ENERGY COMPLETE MONOGRAPH

**2021 PUBLIC INPUT TO THE 2021 IECC, IRC CH. 11 AND
ICCPC CH.15**

Publication Date: November 2021

**FIGURE C301.1
CLIMATE ZONES**

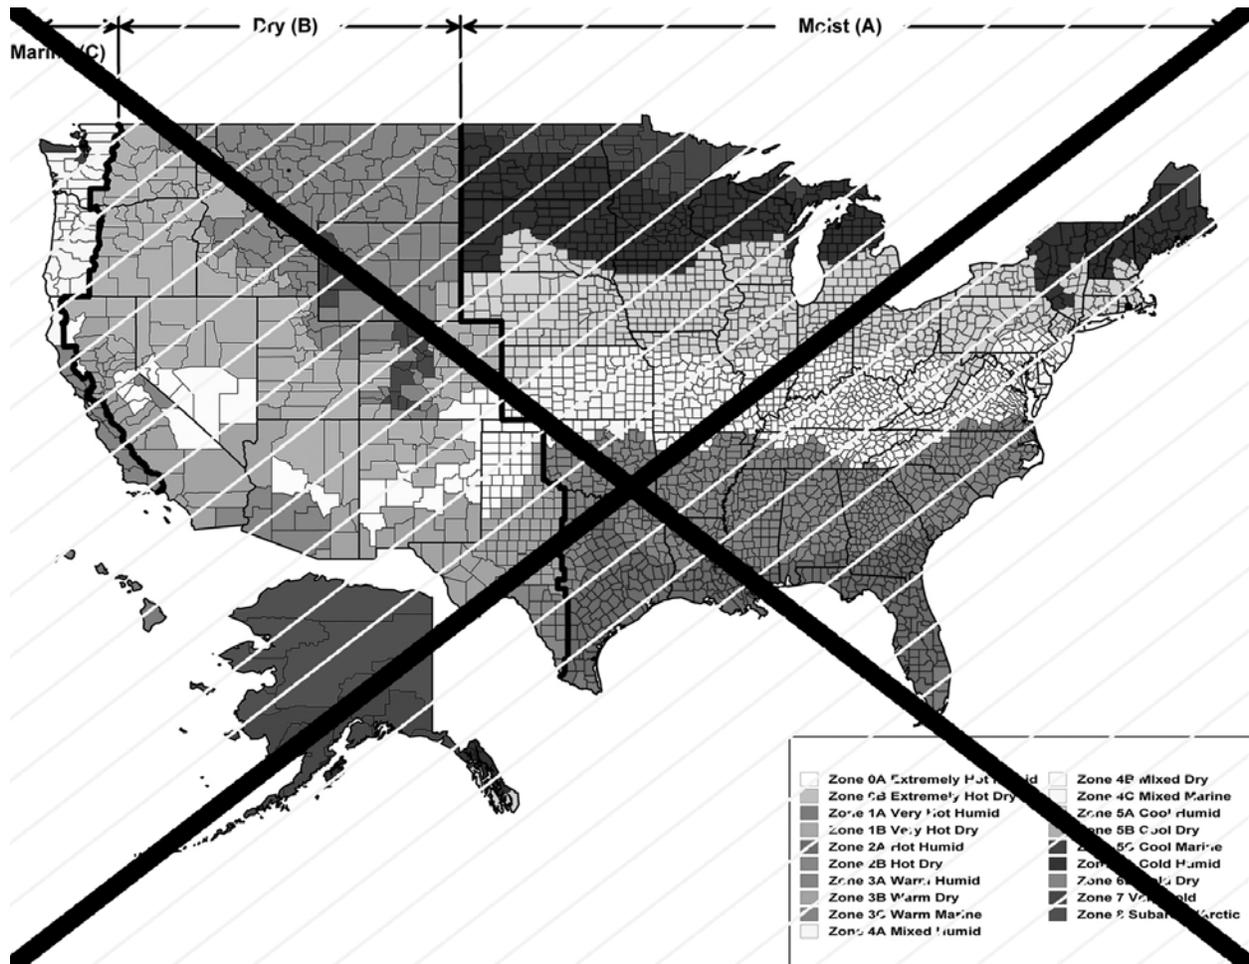
C301.1 General. *Climate zones shall be as specified in R301.* ~~from Figure C301.1 or Table C301.1 shall be used for determining the applicable requirements from Chapter 4. Locations not indicated in Table C301.1 shall be assigned a *climate zone* in accordance with Section C301.3.~~

Delete without substitution:

FIGURE C405.2.4.2(2)
DAYLIGHT ZONE UNDER A ROOFTOP MONITOR

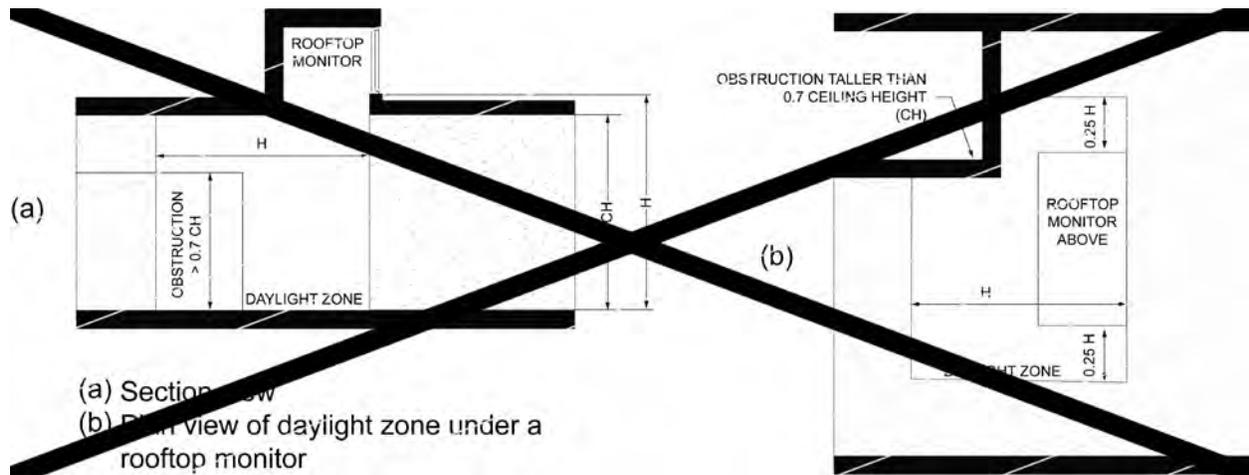
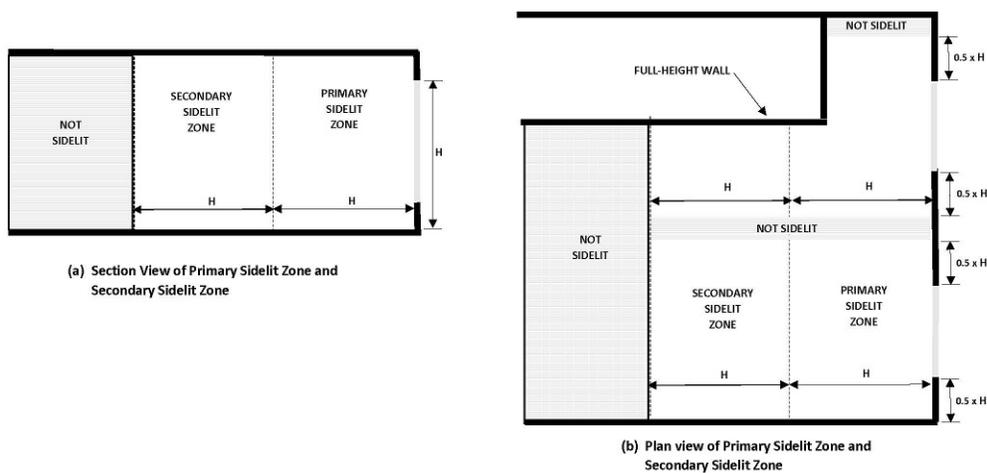
Delete and substitute as follows:

(a) Section View of Primary Sidelit Zone and Secondary Sidelit Zone

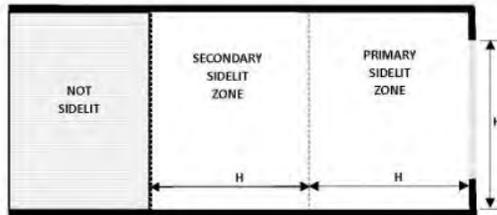
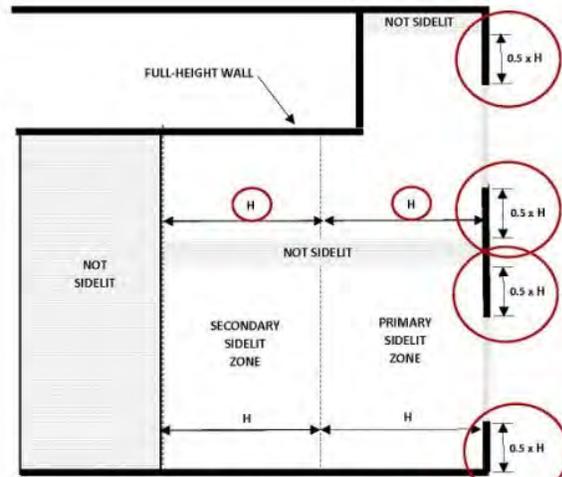
Reason: Figure C405.2.4.2(1) is incorrect. The definition for a sidelit daylight zone is to extend longitudinally from the edge of the fenestration up to 0.5 times the height from the floor to the top of the fenestration. Figures attached show in red outline where the figure needs correction in order to match the definition of a sidelit daylight zone in C405.2.4.2.

1. Where the fenestration is located in a wall, the primary sidelit daylight zone shall extend laterally to the nearest full-height wall, or up to 1.0 times the height from the floor to the top of the fenestration, and longitudinally from the edge of the fenestration to the nearest full-height wall, or up to 0.5 times the height from the floor to the top of the fenestration, whichever is less, as indicated in Figure C405.2.4.2(1).

3. Where the fenestration is located in a wall, the secondary sidelit daylight zone is directly adjacent to the primary sidelit daylight zone and shall extend laterally to 2.0 times the height from the floor to the top of the fenestration or to the nearest full height wall, whichever is less, and longitudinally from the edge of the fenestration to the nearest full height wall, or up to 0.5 times the height from the floor to the top of the fenestration, whichever is less, as indicated in Figure C405.2.4.2(1). The area of secondary sidelit zones shall not be considered in the calculation of the daylight zones in Section C402.4.1.1.
